## **REMARKS/ARGUMENTS**

Appn No. 10/699,765  
Reply to Office action  
of June 24, 2005  
Annotated Sheet showing  
Drawing Changes

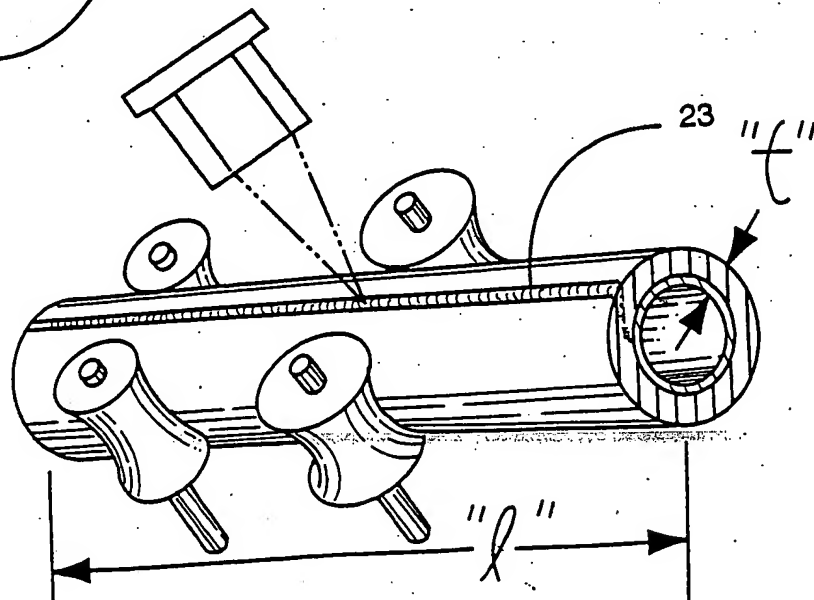
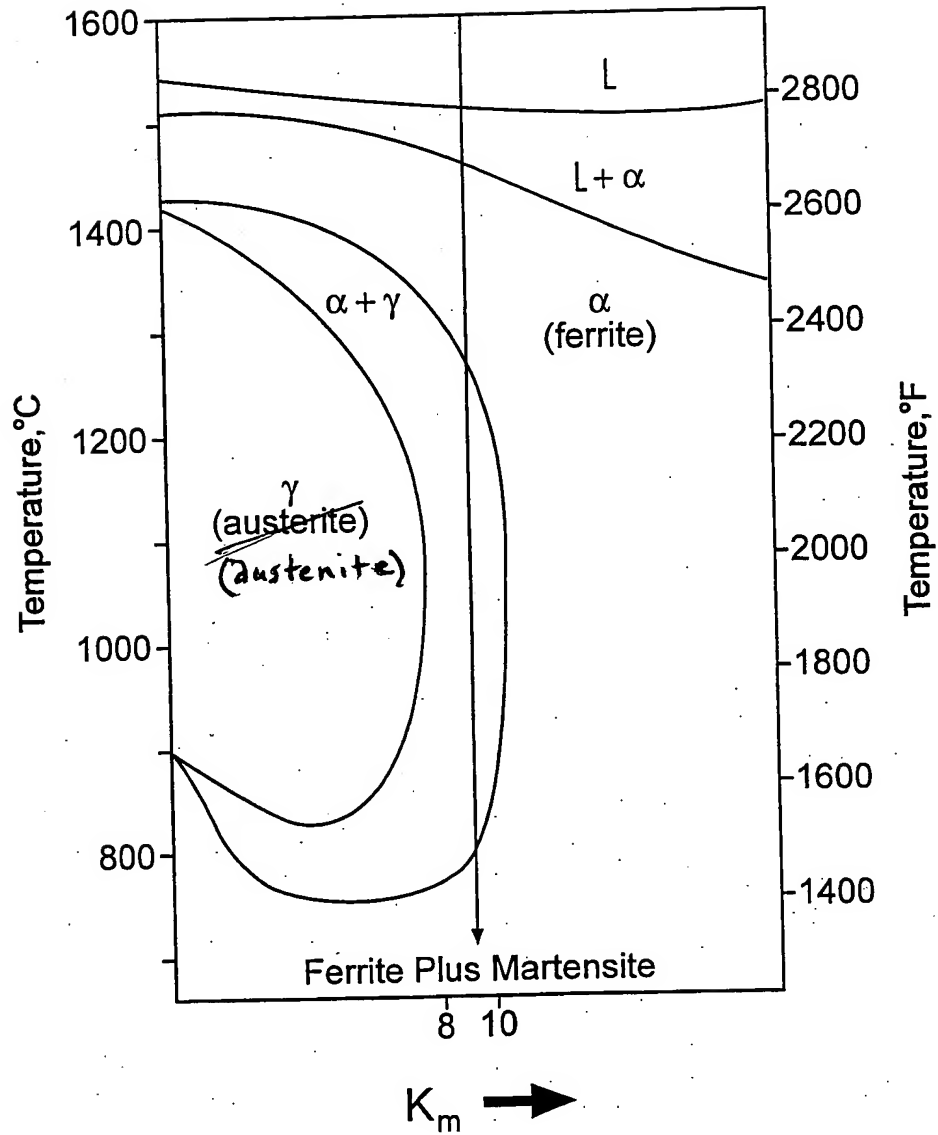
The Examiner objected to the drawings in that the longitudinal roller set 20 was not shown in Figure 2 and that element 19 was not mentioned in the Specification. The Examiner also pointed out the misspelling of the word "austenite" in Figure 4. Applicant has made the required drawing changes and replacement drawing sheets are attached as a part of this response.

The attached two sheets of drawings include changes to Figures 2 and 4. These attached two sheets, which include Figures 2 and 4, replace the original sheets including Figures 2 and 4. In Figure 2, the number "19" referring to the lower roller set has been corrected to "20" so that the drawings agree with the language of the Specification as originally filed. In Figure 4, the spelling of the term "austerite" has been corrected to "austenite." Also attached are annotated sheets showing the drawing changes in red.
